CNL-17-070

Clinch River Nuclear Site
NRC Docket No. 52-047

Subject: Submittal of Supplemental Information Associated with Hydrologic Engineering in Support of the Clinch River Nuclear Site Early Site Permit Application

Supplemental Information Regarding Site Safety Analysis Report Section 2.4, "Hydrologic Engineering"

Figure 2.4.1-5 Tennessee River System (Sheet 2 of 2)

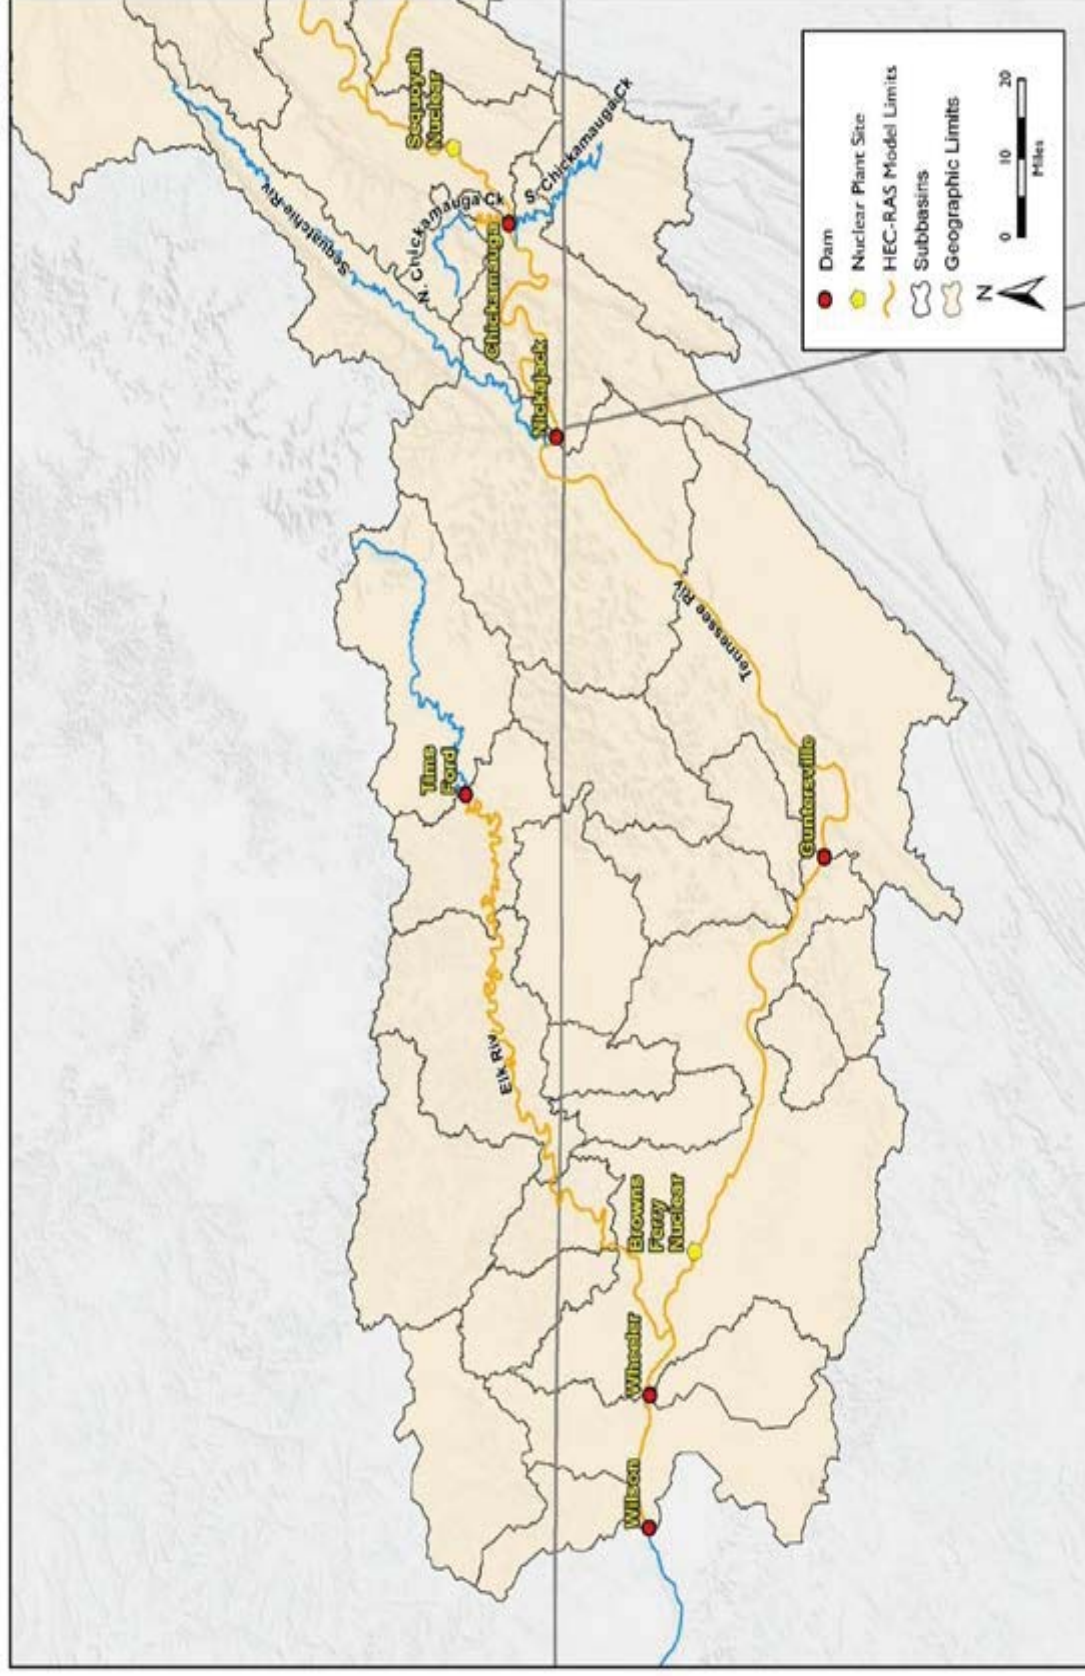
A GIS map showing the location of all dams upstream of Watts Bar Dam in relation to the layout of the Tennessee River and its tributaries is being added to the SSAR. Existing Figure 2.4.1-5 is being removed and replaced with new Figure 2.4.1-5, "Tennessee River System," Sheets 1 and 2 of 2. A copy of the new Figure 2.4.1-5, Sheets 1 and 2 of 2 is provided in Attachment 1.

Table 2.4.3-1
Flood Events Analyzed

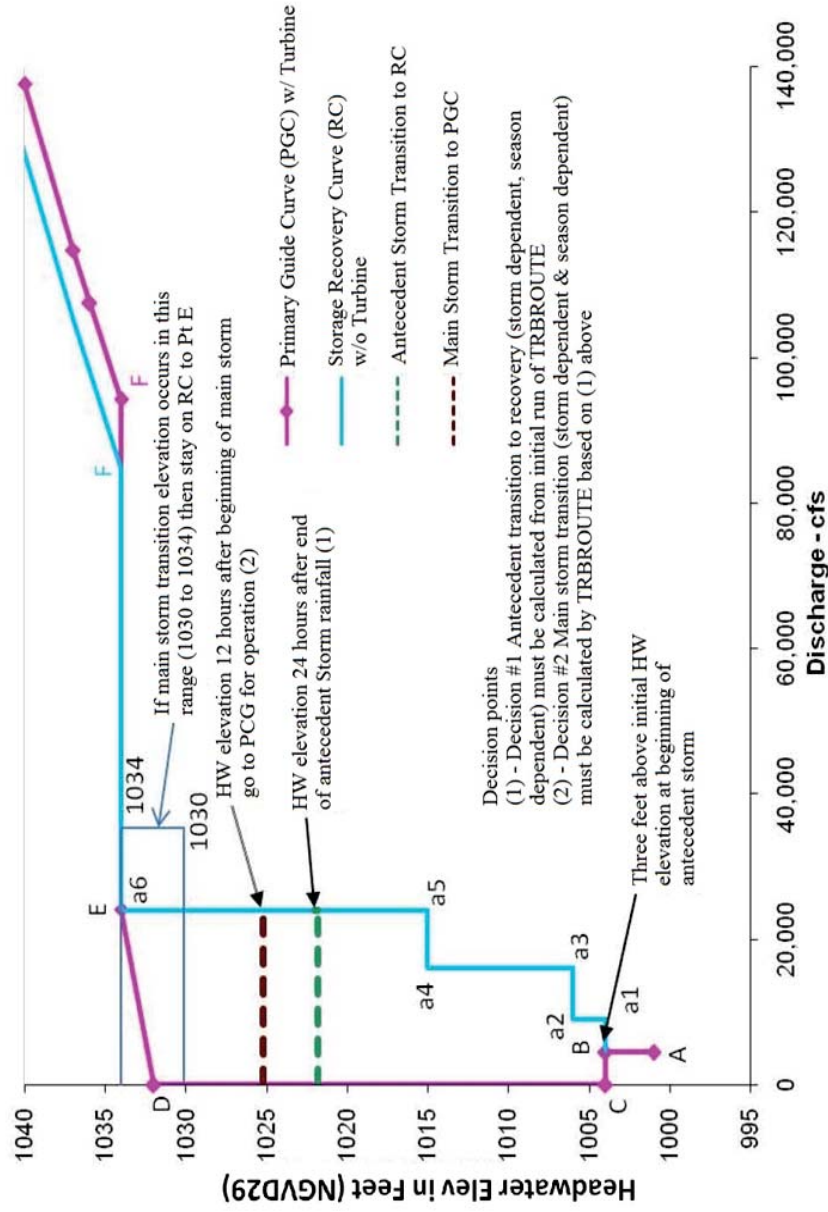
A discussion of the methods and calculations of the PMP development for the four types of events is being added to SSAR Subsection 2.4.3.2, "Probable Maximum Precipitation." Table 2.4.3-1, "Flood Events Analyzed," is being revised to add precipitation depths and velocities and to add clarifying footnotes. See the markup provided in SSAR Subsection 2.4.3.2 and SSAR Table 2.4.3-1 in Attachment 3.

Figure 2.4.3-4. Flood Operational Guide –Norris Dam (Sheet 1 of 2)

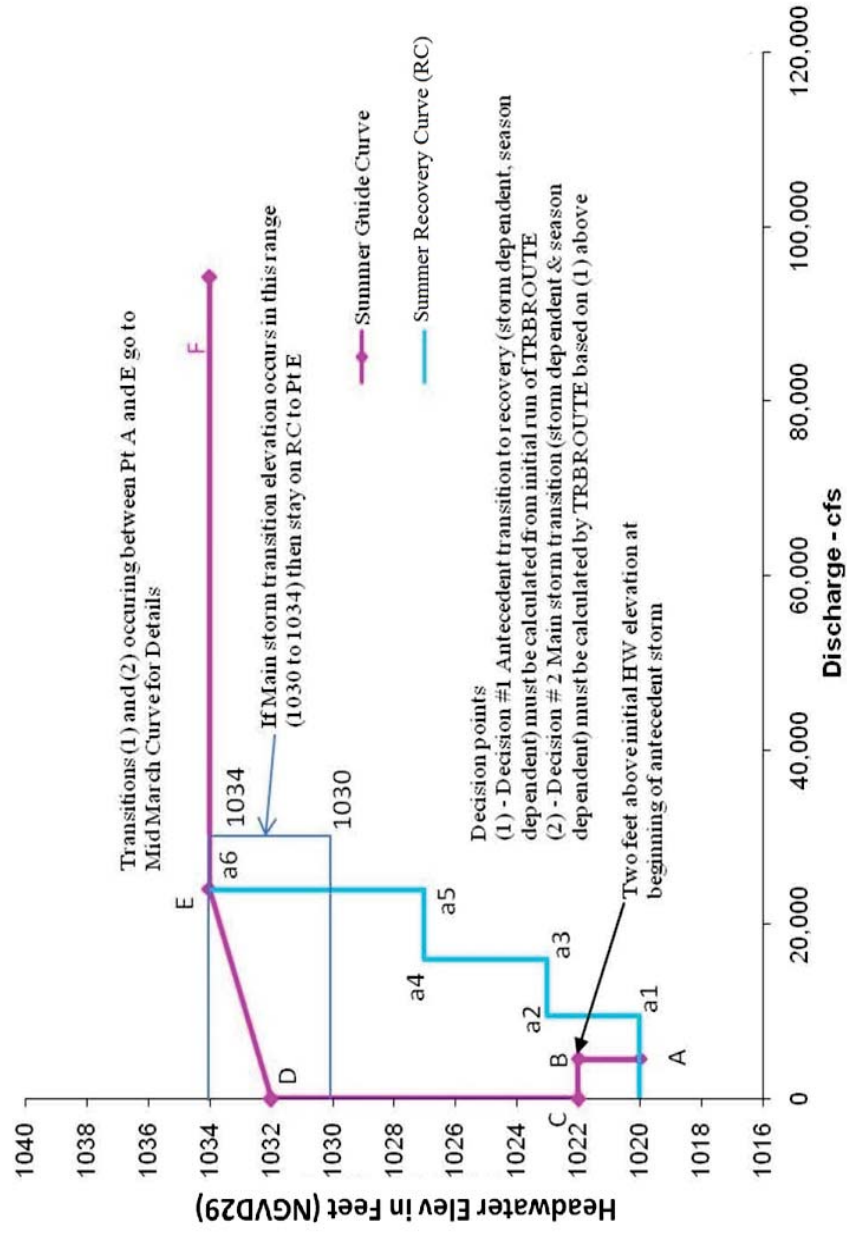
A discussion to provide the operational curve of the Norris Dam as well as the various cases presented in the rating curve figures and their application to the HEC-RAS simulations is being added to SSAR Subsection 2.4.3.4.4, "Design Storm Implementation." In addition, SSAR Figure 2.4.3-4, Sheets 1 and 2 are being revised and Figure 2.4.3-7, Sheet 2 of 2 is being removed. See the markup provided in SSAR Subsection 2.4.3.4.4, fourth and fifth paragraphs, and the last four sentences of this Subsection, revised Figure 2.4.3-4, Sheets 1 and 2, and Figure 2.4.3-7 is shown removed, in Attachment 3.

Figure 2.4.3-4 Sheets 1 and 2 are modified and replaced with new Figure 2.4.3-4 Sheets 1 and 2

Figure 2.4.3-4 demonstrates the current operational guide for mid-March at Norris Dam. At Point (Pt) A (starting point) on the curve, the turbine discharge is 4500 cfs and discharge is controlled by the spillway gates, turbine outflow, and sluices. As flood waters enter the reservoir and increase the headwater to 1005 feet, turbine operation ceases and sluices and spillway gates are closed (Pt B to C) (Figure 2.4.3-4). As flood waters continue to enter the reservoir with the discharge outlets closed, the reservoir elevation reaches 1032 feet (Pt D). At elevation 1032 feet, spillway gates begin to open and sluiceway operation is adjusted to allow an increasing discharge until the headwater elevation reaches 1034 feet (Pt E). At this elevation, gates continue to be raised to increase flow and sluices and turbines are adjusted to maintain 1034 feet headwater elevation (Pt F) until discharge points are at fully capacity and flow transitions to the dam rating curve. As additional flood waters enter the reservoir, the reservoir headwater elevation response is as indicated by Case 1 of the Norris Dam rating curve, Figure 2.4.3-7. As the flood waters recede, the operational guides follow the flood accession curve in reverse order to Pt E on Figure 2.4.3-4 at a discharge of 24,000 cfs. At this point, spillway gates and sluices are operated to decrease reservoir elevation until elevation 1015 feet

Figure 2.4.3-7. Dam Rating Curve – Norris Dam (Sheet 1 of 2)

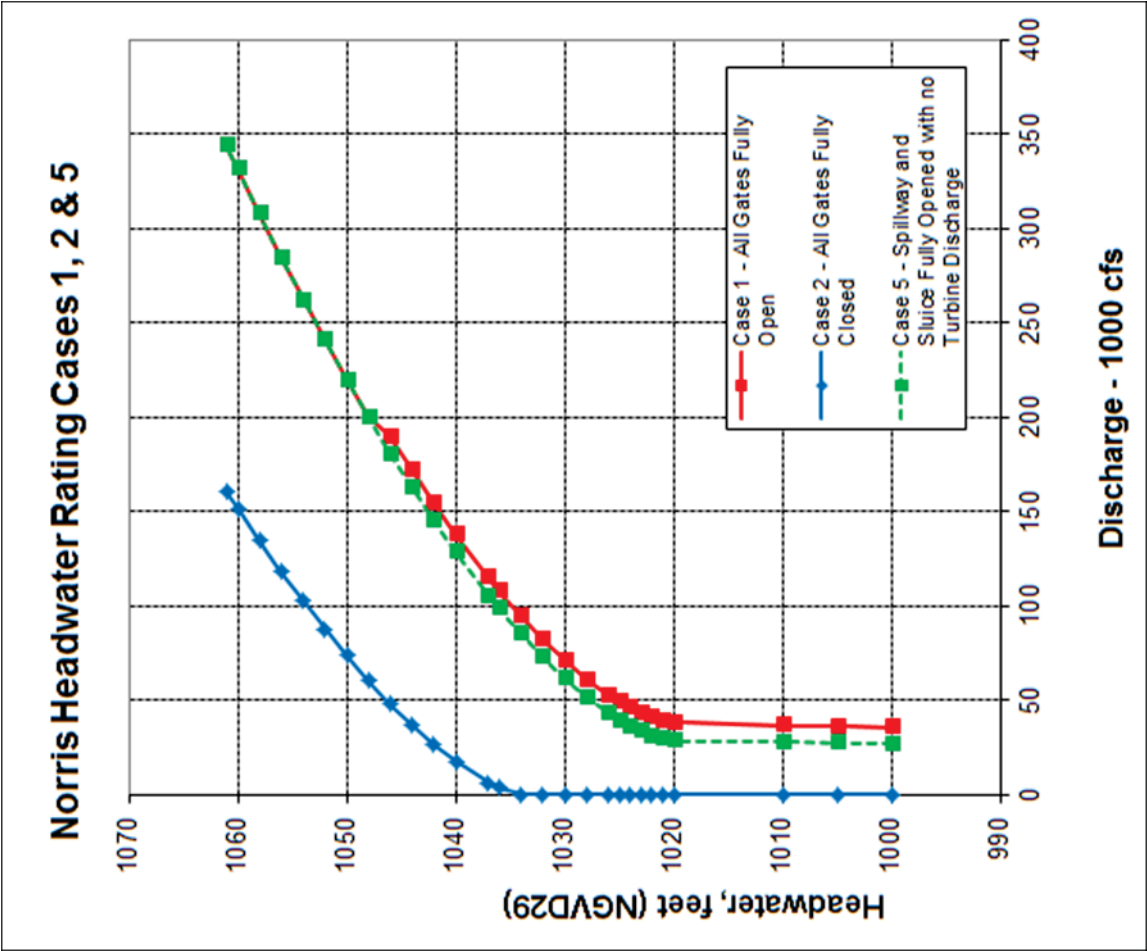
Figure 2.4.3-7. Sheet 2 of 2 is removed

Figure 2.4.3-10. Watts Bar Reservoir Calibration Results - Elevation: 1973 Flood Event

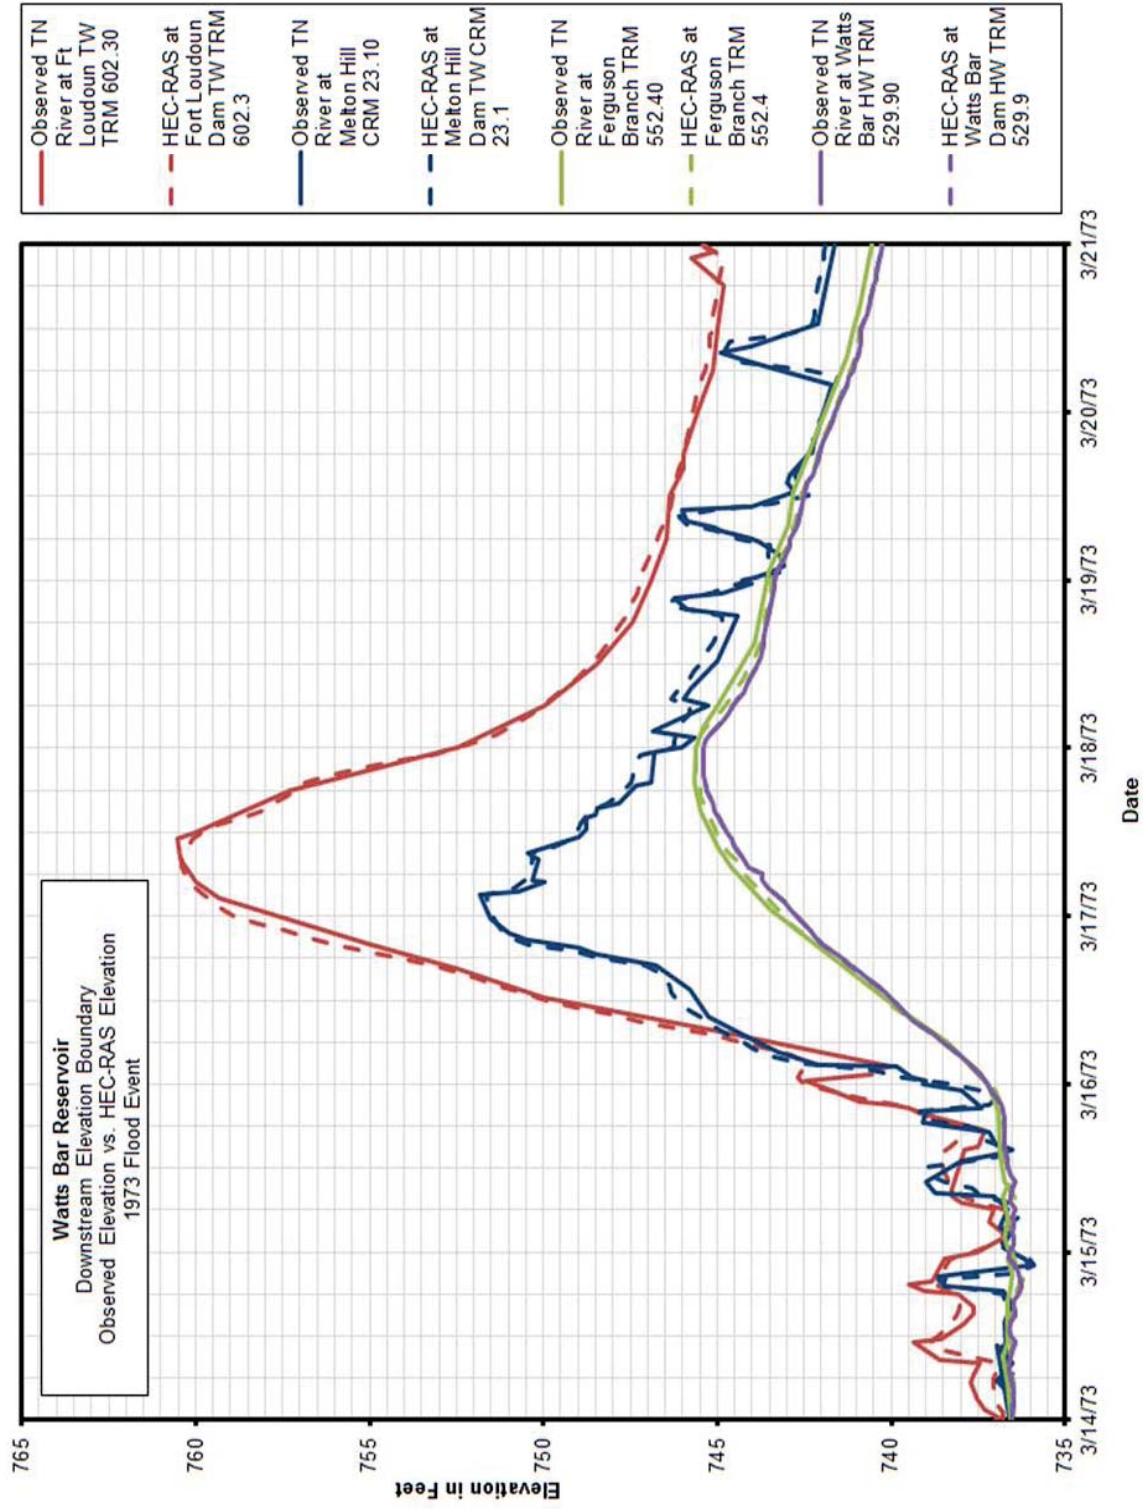
Reference to new Figures 2.4.3-10 through 2.4.3-13, is being added to SSAR Subsection 2.4.3.4.3 to provide calibration points and calibration results for the Watts Bar and Melton Hill Reservoirs. Reference to new Figures 2.4.3-14 and 2.4.3-15 is being added to the SSAR to the calibration point and the calibration result for the Clinch River above Norris Dam. See the markup provided in SSAR Subsection 2.4.3.4.3, ninth, tenth, and eleventh paragraphs, and addition of new Figures 2.4.3-10 through 2.4.3-15 in Attachment 3.
